TRANS/WP.29/GRE/2002/42
18 July 2002

PROPOSAL FOR DRAFT AMENDMENTS TO REGULATION No. 112

(Headlamps emitting an asymmetrical passing beam)

Transmitted by the Expert from the Working Party "Brussels 1952" (GTB)

Figure 1:

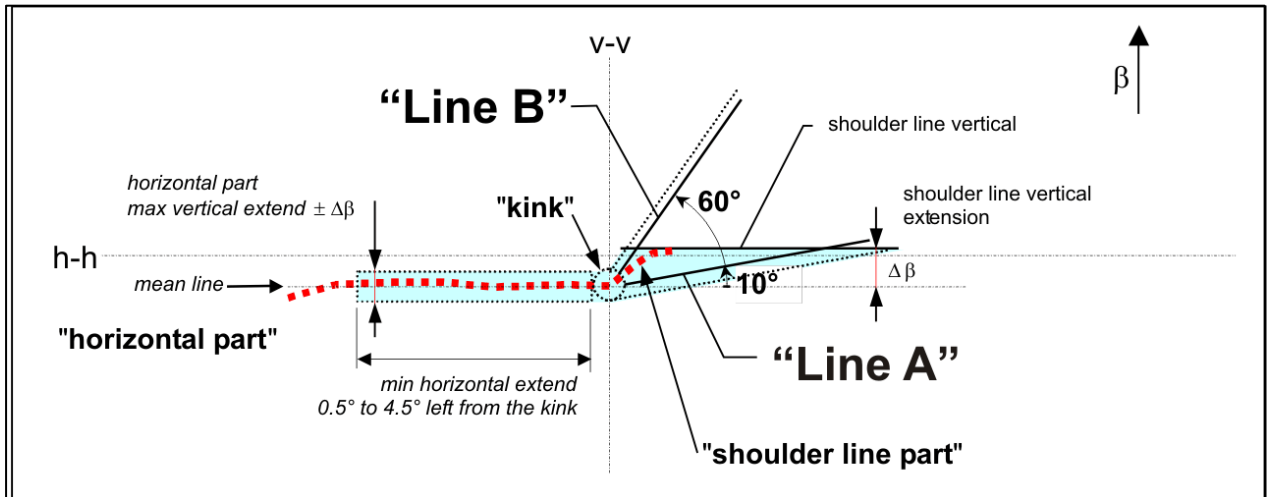
For visual adjustment of the passing beam the cut-off line shall provide a horizontal line for vertical adjustment of the headlamp between 0.5° and 4.5° distant from the v-v-line (see Figure1), which does not exceed a vertical extend of $\Delta b = 0.2$ degree up or down.

Figure 2:

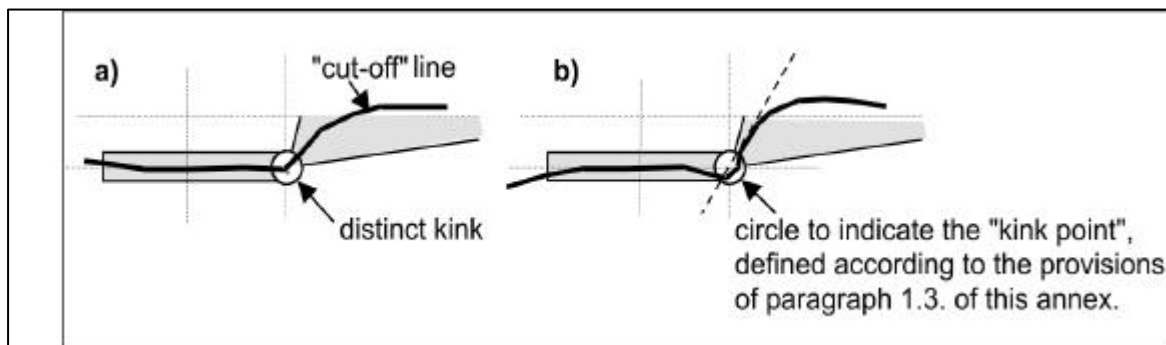
"elbow" is situated at the v-v-line. If the "elbow" forms no sharp enough edge, that point shall be taken, where the horizontal line through the straight part and the steepest tangential line onto the shoulder part of the cut-off line are crossing (for examples see Figure 2). The "shoulder line part"

- (a) does not extend the tangential line "B" going from the "kink" upwards to the right and being inclined versus h-h by 60° ;
- (b) does not extend the tangential line "A" going from the "kink" upwards to the right and being inclined versus h-h by 10° .
- (c) has a vertical extension of at least $Db = 0.57^\circ$ over a distance of 2° to the left (right hand traffic) and 2° to the right (left hand traffic).

Figure 3:

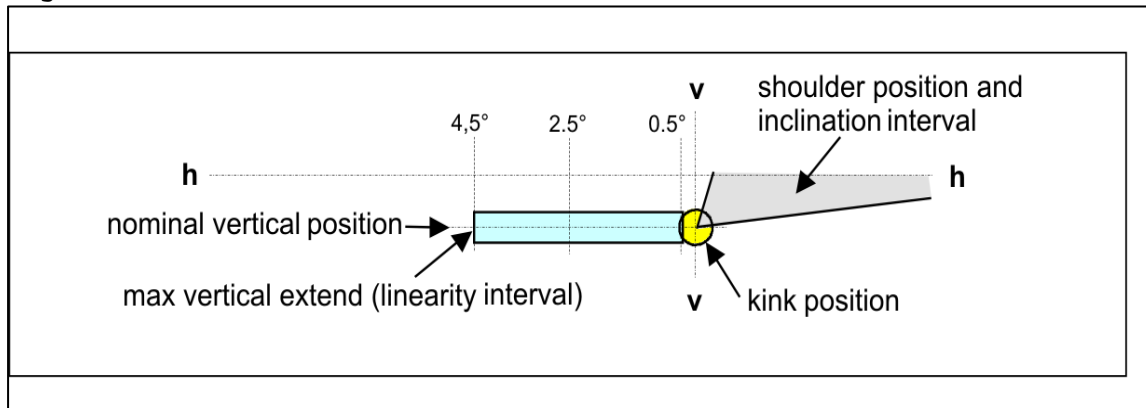
The part of the cut-off line which serves vertical adjustment shall be horizontal between 0.5° and 4.5° distant from the V-V-line. This requirement is deemed to be met when the vertical position of the inflection points (where $d^2(\log E) / d\beta^2 = 0$) at 1.5°, 2.5° and 3.5° horizontal distance from the v-v-line are located within a band width of + 0.2° from the nominal vertical position of the cut-off line at 2.5° sideward of the v-v-line, see Figure 3.
